Memo

To:	Katsky Venter, TMAC Lea-Marie Bowes-Lyon, TMAC	Client:	TMAC Resources Inc.
From:	Lisa Barazzuol	Project No:	1CT022.001.310
Cc:	Dave King, TMAC Paul Christman, TMAC	Date:	April 17, 2014
Subject:	Doris Type A Water License Expansion Application - IR #10: Waste Rock Quantities and Management

Pad U
General Arrangement

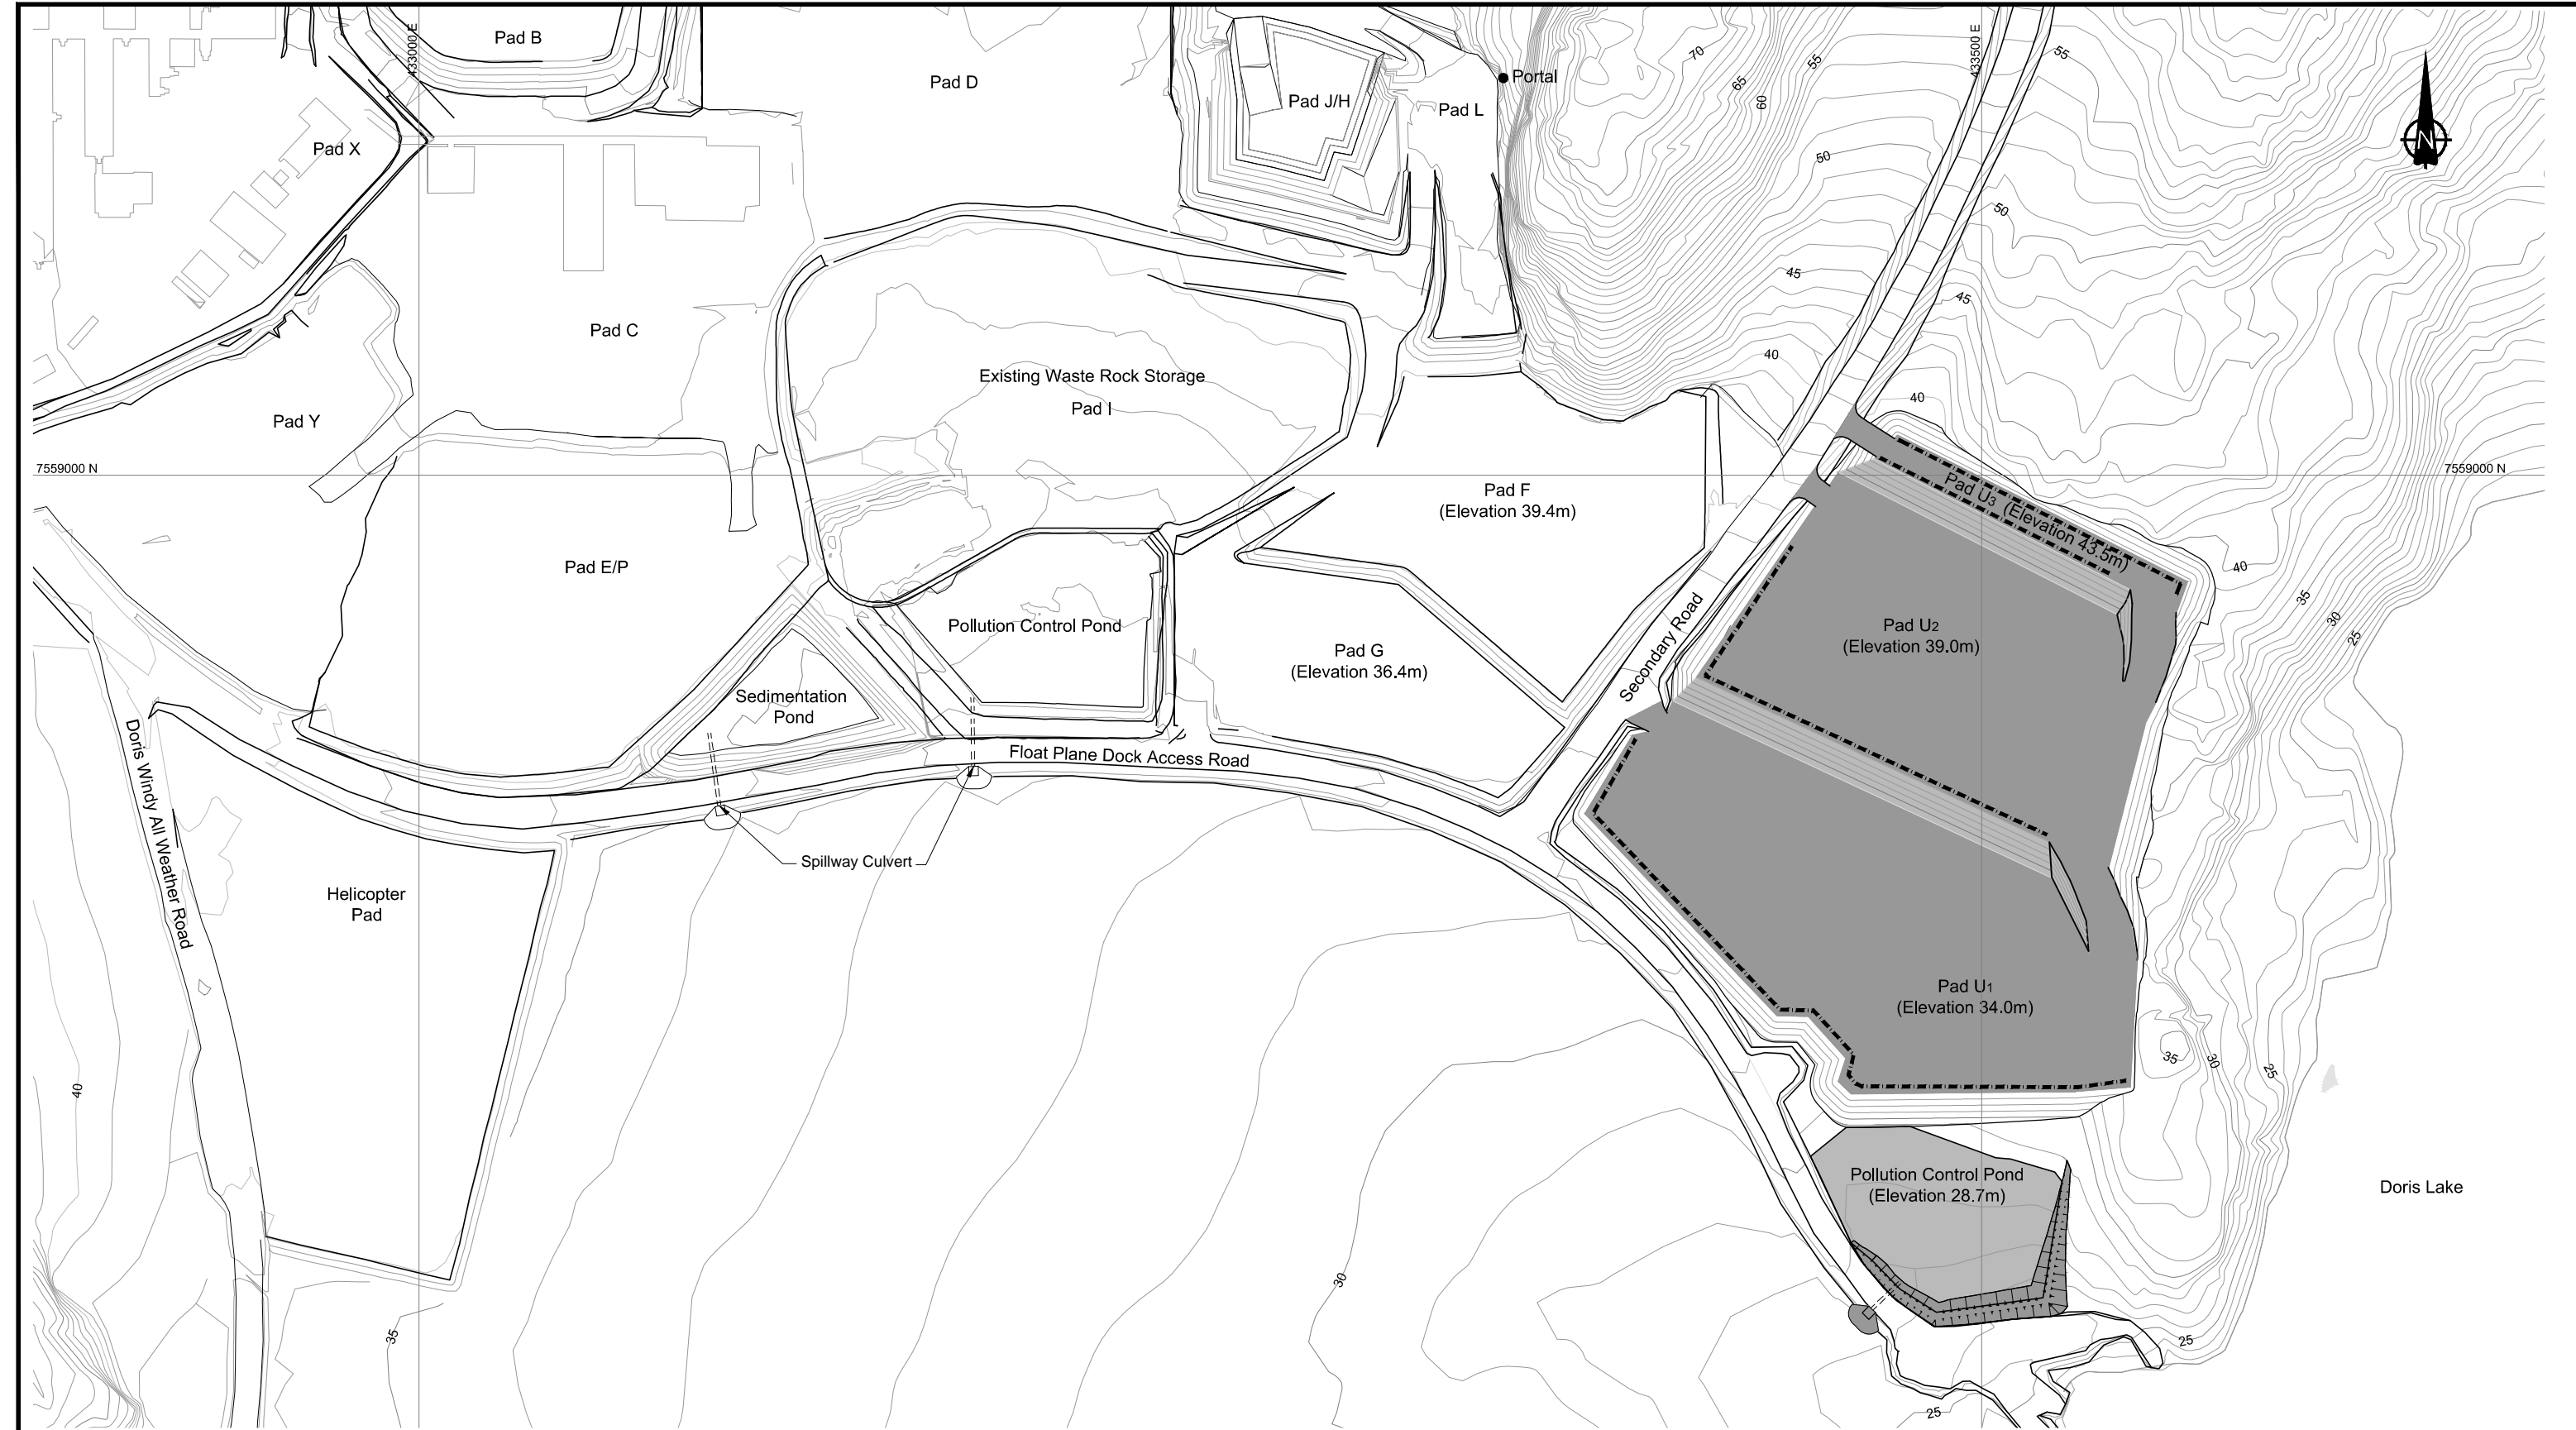
1. Breakdown of the total volumes of waste rock from the project expansion that would be classified as mineralized and non-mineralized and how they will be managed.
2. The total volume of mineralized waste rock from the proposed expansions that will be potentially acid generating (PAG) and non-PAG.
3. The total volume of mineralized waste rock that will end up being stored on-land in the waste rock storage pads and whether there will be any PAG materials in these on-land pads.

Low risk waste rock units would be stockpiled on surface. Storage pads F, I, G and U have been assigned for waste rock stockpiling (Figure 1).

2. Of the 882,906 tonnes of moderate risk waste rock from the proposed expansion, 68,825 tonnes is expected to be potentially acid generated (PAG), 132,450 tonnes has an uncertain classification and 683,650 tonnes is non-PAG. Approximately half of the 68,825 tonnes of PAG waste rock is from Doris North.
3. Current projections indicate that the total volume of the waste rock stockpile on surface at closure is approximately 1,200,000 tonnes, of which approximately 40% (or 506,500 tonnes) is from the Doris North mine with the balance (693,500 tonnes) from the proposed Doris expansion. At closure, all stockpiled waste rock is expected to be non-mineralized waste.
